**Re: 48 Grenoble Drive Response to Transportation Comments
4th Submission
City File: 22 127125 NNY 16 OZ
Project No.: 300054545.0000**

R.J. Burnside & Associates Limited (Burnside) has reviewed the City of Toronto's (the City) transportation-related comments in the Transportation Services letter, dated May 16, 2023. Meetings with the City were also held on June 16, 2023, and July 12, 2023, to discuss these comments.

DEAUVILLE LANE AT GRENOBLE DRIVE ROAD RECONSTRUCTION PLAN							
DESIGN	B.P.Q.	DRAWN	A.K.S.	CHECKED	D.S.W.	CONTRACT No. 19TRA-TIM-01CIP	
SCALE	HORIZONTAL 1:200			DRAWING NUMBER	15M-00215-25-003		SHEET 3 OF 9
DATE	JULY, 2019

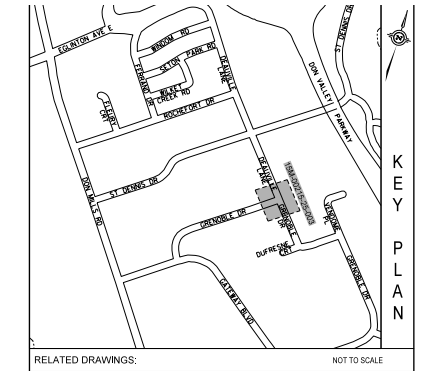
5. Please ensure consistency between the survey plan, the existing configuration design of the intersection of Grenoble Drive and Deauville Lane, and the proposed site plans. Be advised, In the event that any design changes are made based on the survey, we reserve the right to request a corner rounding in subsequent submissions;

The City provided the proposed configuration of the intersection of Grenoble Drive and Deauville Lane, which is provided in Attachment 3. The site plan reflects the City's proposal, as shown in Attachment 1.

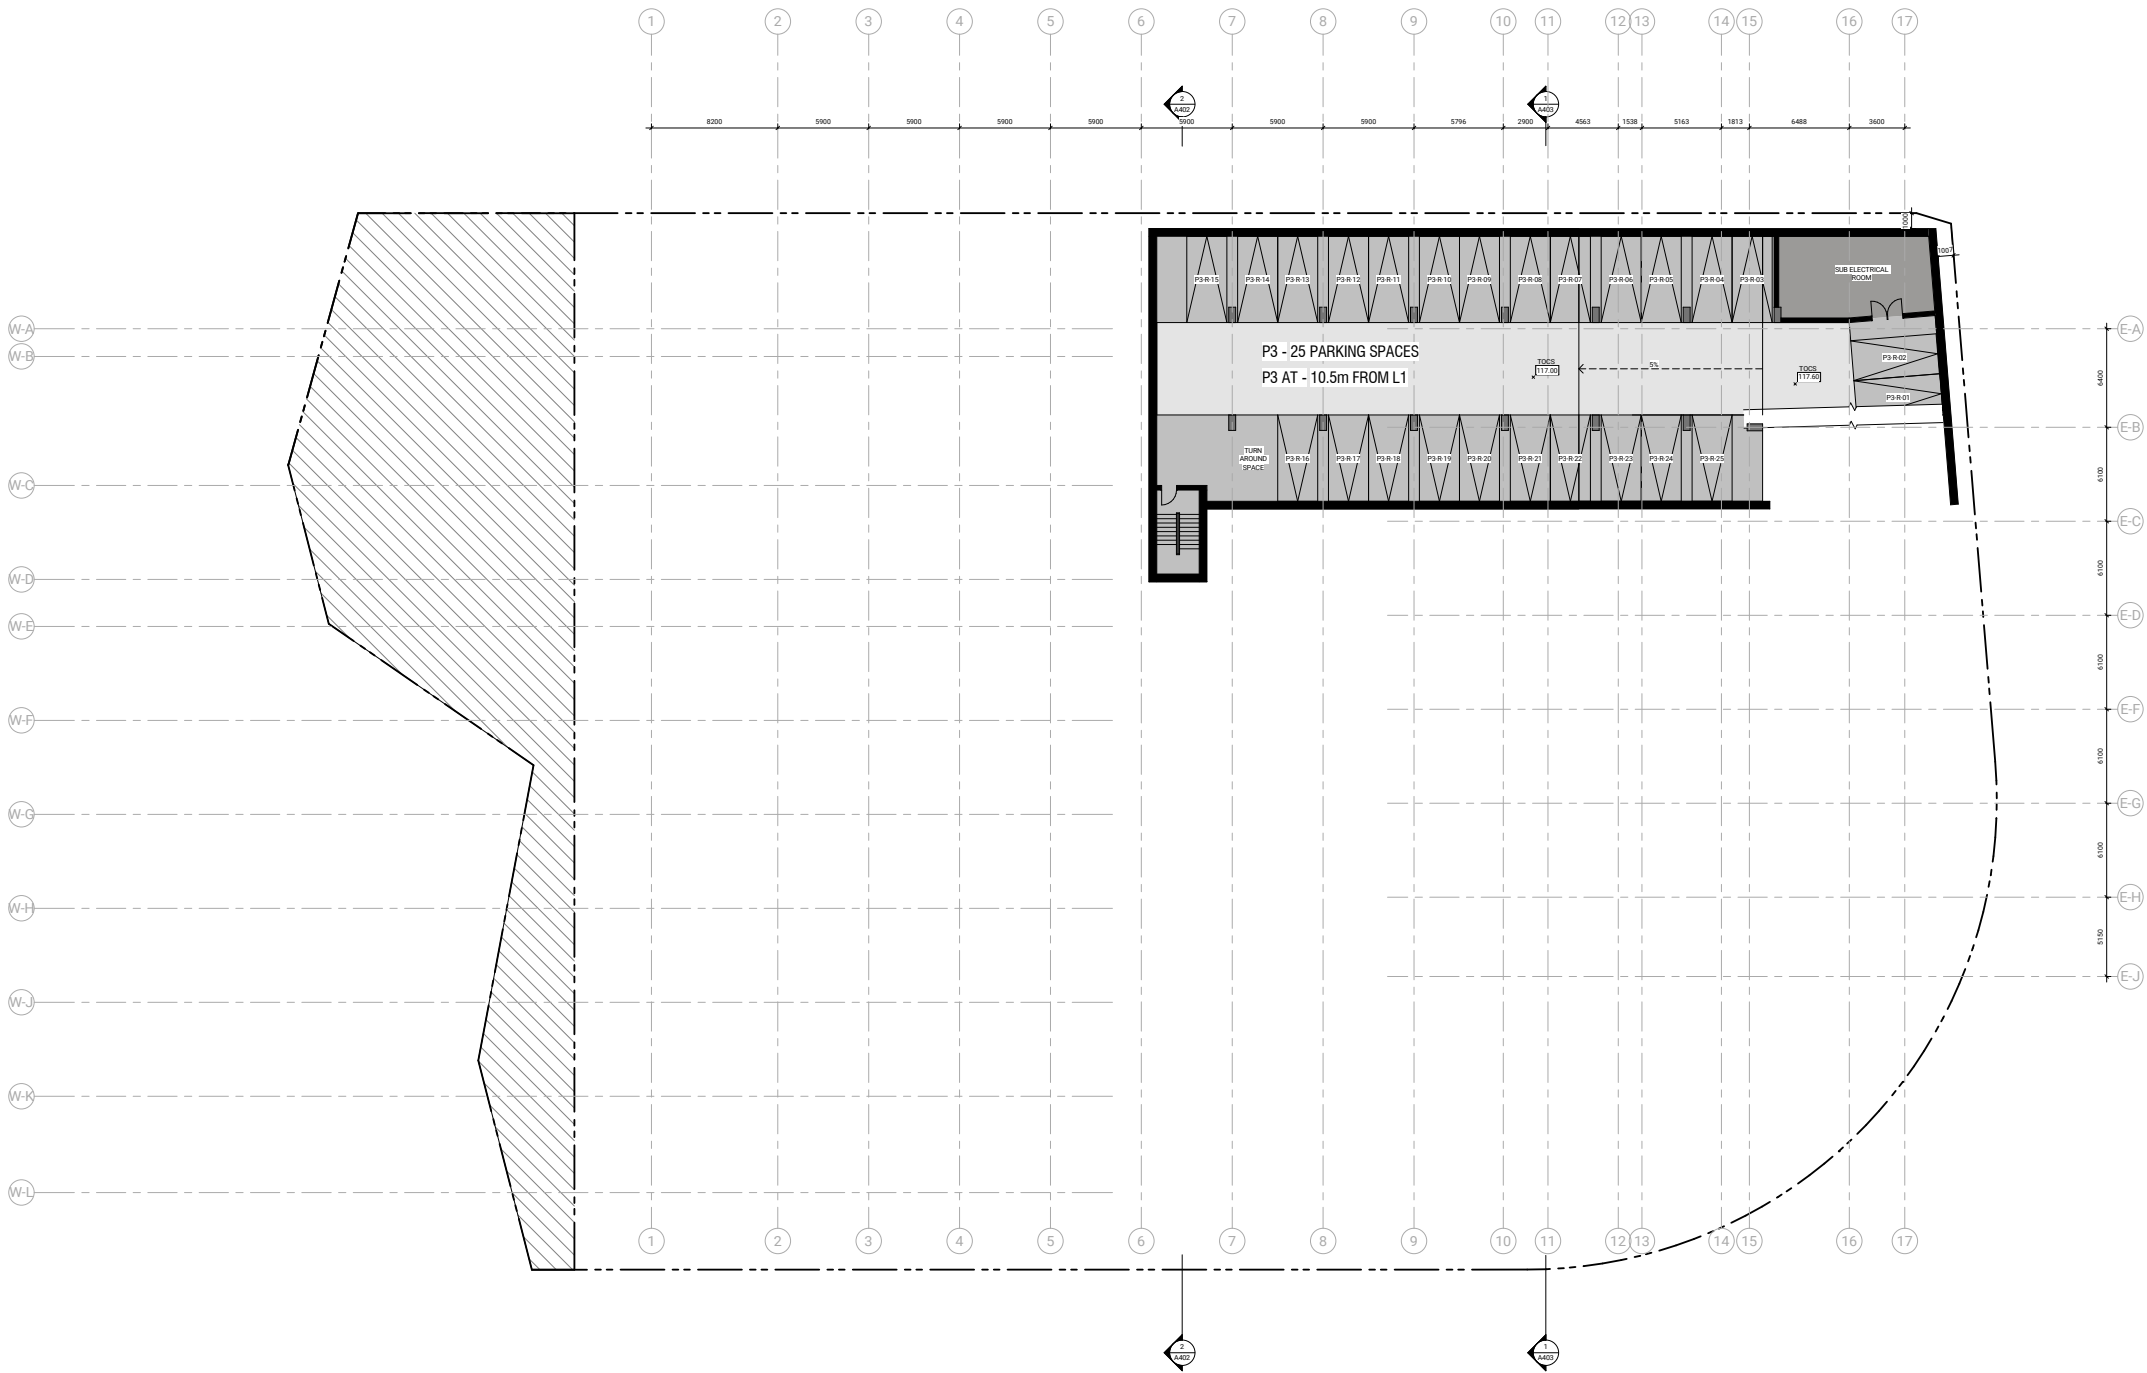
7. Please label the dimension of all parking spaces. Clearly identify the distance of the parking spaces from walls and obstructions. The minimum dimensions of a parking space are 2.6m wide by 5.6m long by 2.0m high. The width must be increased by 0.3m for each side of the parking space that is obstructed more than 1.0m from the front or back of a parking space.

As discussed during the meeting with the City on June 16, 2023, typical parking space dimensions are shown in place of labelling all parking spaces. Please see the updated parking level plans in Attachment 4, which shows the dimensions of a typical parking space and that it complies with the City's ZBL.

Figure 11: Site Generated Vehicle Traffic

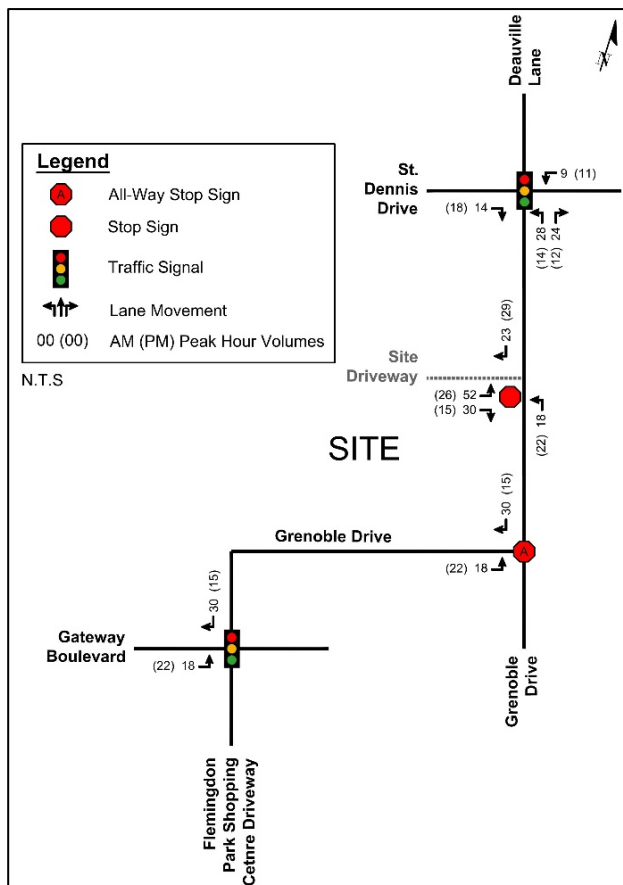
Based on the Traffic Impact Study (TIS) and vehicle trip distribution (see Table 6, dated March 2022), it was assumed that 80% of vehicle trips would utilize St. Dennis. However, upon reviewing the traffic operations data (refer to Table 1 and Table 2, Attachment 5, dated February 8, 2023), it appears that the level of service (LOS), delay, and queue lengths

A call was held with the City on July 12, 2023, where further clarification from the City was requested on this comment. As per the call, the City requested further information regarding the assumed vehicle trip distribution in the TIS and the difference in the level of service, delay and queue lengths between background and total conditions.

As noted in Section 4.2 of the TIS, the overall site vehicle trip distribution was based on the findings from the *Don Mills Crossing – Mobility Planning Study*, dated February 2019 (Don Mills Crossing Study). Excerpts from Section 4.2 of the TIS and the Don Mills Crossing Study are provided in Attachment 5. However, the TIS did not assume that 80% of all site trips would utilize St. Dennis, as noted in this comment. As shown in Table 6 of the TIS, 30% of site trips are projected to travel to/from the east via Eglinton Avenue, and 80% of this portion of site trips will be routed through St. Dennis, due to its direct access to Eglinton Avenue.
